Construction Impact Assessment &

Tree Preservation Plan

Date of Issuance: November 1, 2019

Jobsite Property: 1114 Rockland Ave, Victoria, BC

BC LAND SURVEYORS SITE PLAN OF:

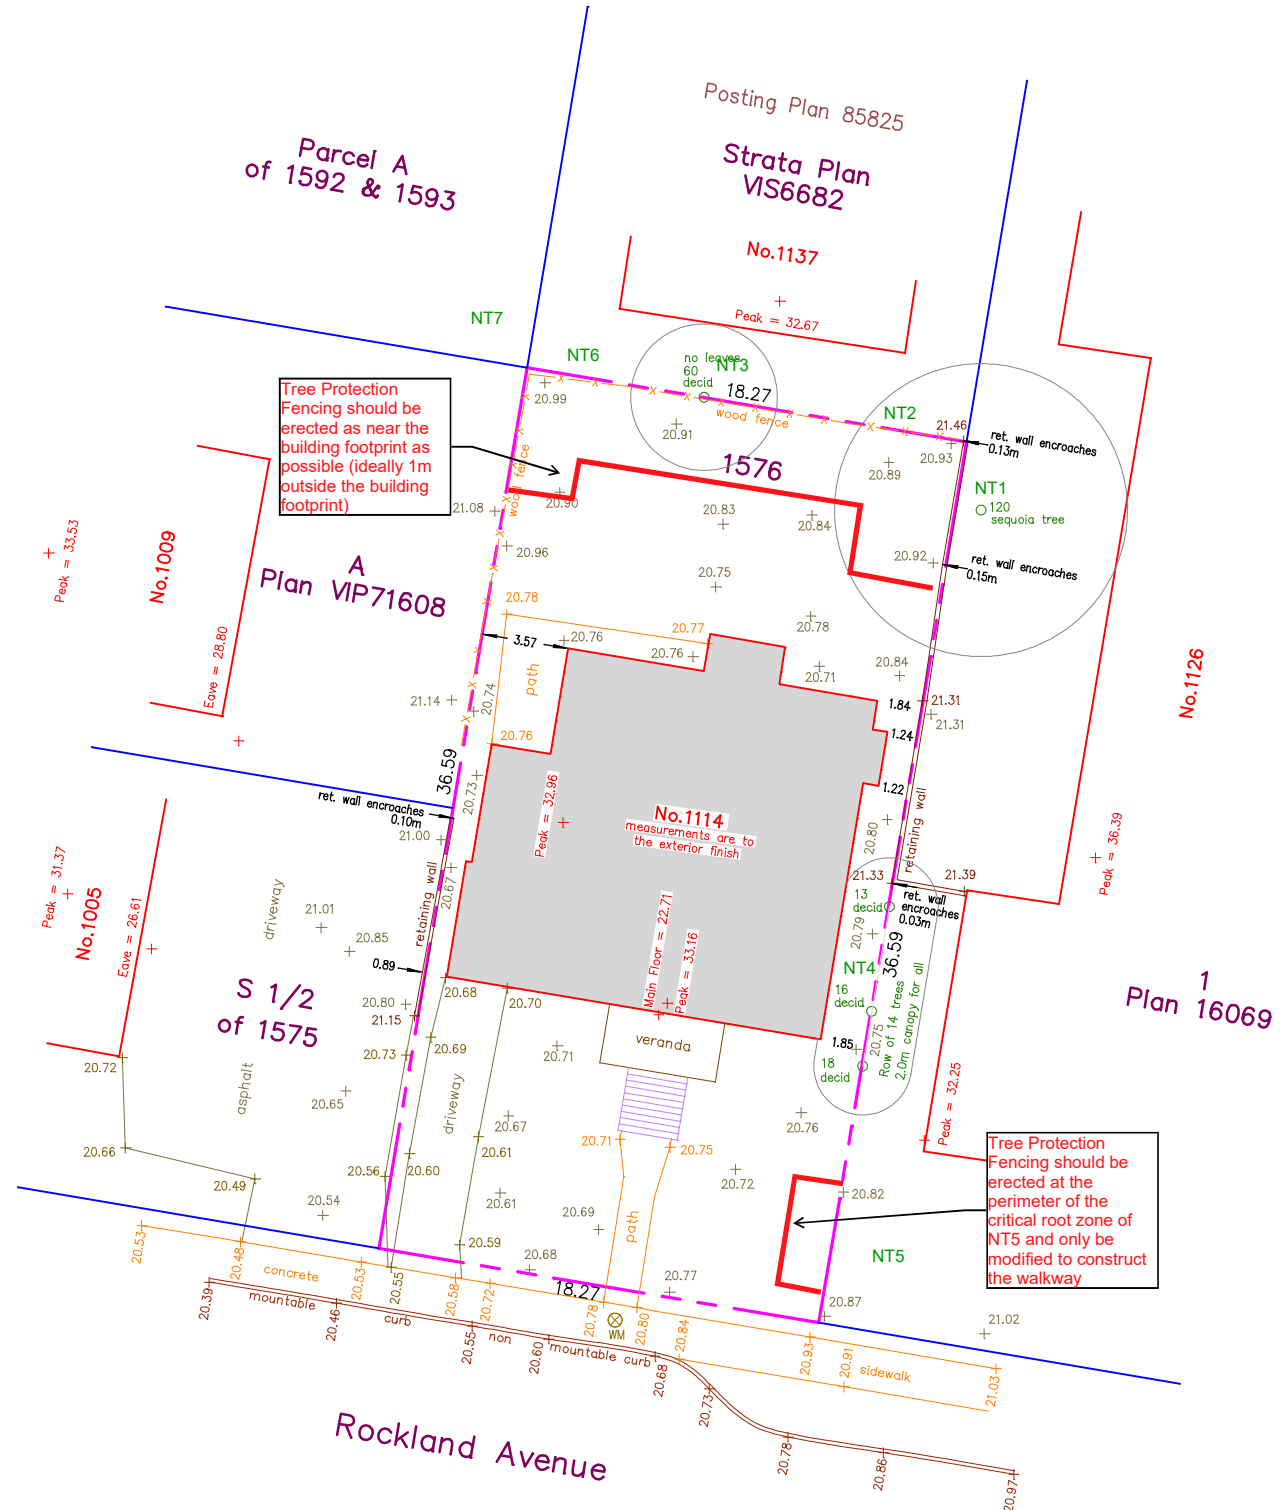
Tree Protection Fencing should be erected as near the building footprint as possible (ideally 1m outside the building footprint)

Tree Protection Fencing should be erected at the perimeter of the critical root zone of NT5 and only be modified to construct the walkway

SITE
2019.09.30 - REVISED PER PLANNING

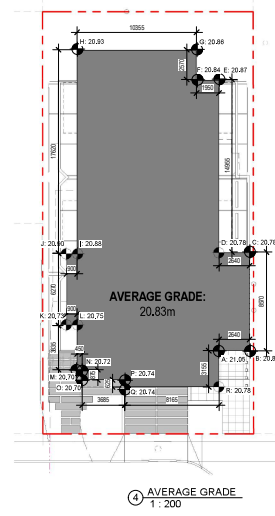
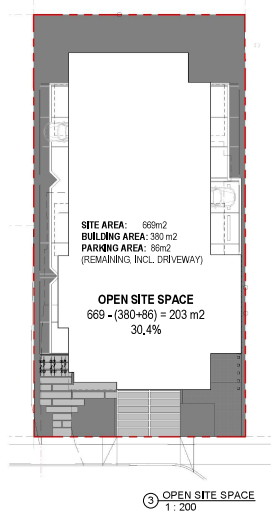
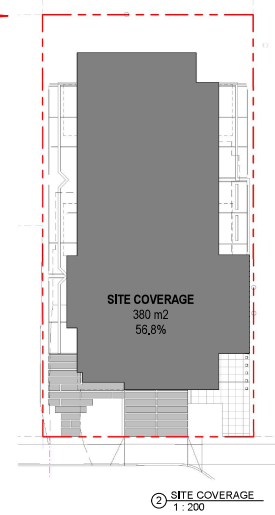
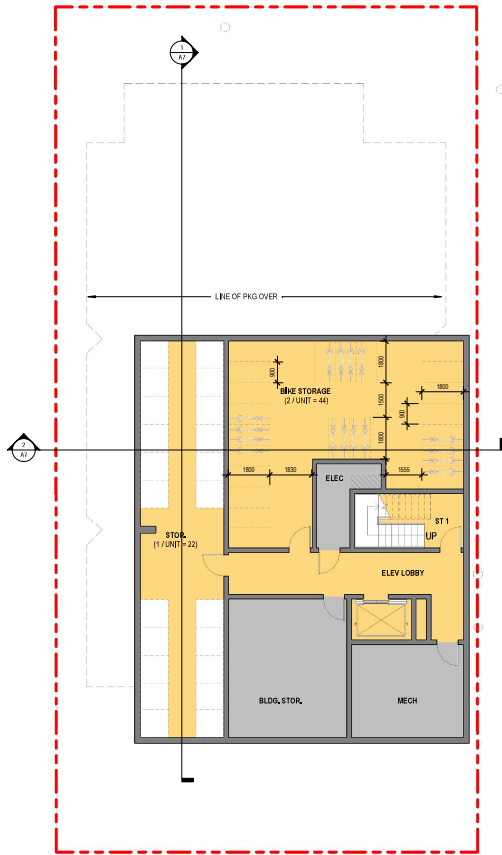
Tree Protection Fencing should be erected as near the building footprint as possible (ideally 1m outside the building footprint)

Tree Protection Fencing should be erected at the perimeter of the critical root zone of NT5 and only be modified to construct the walkway
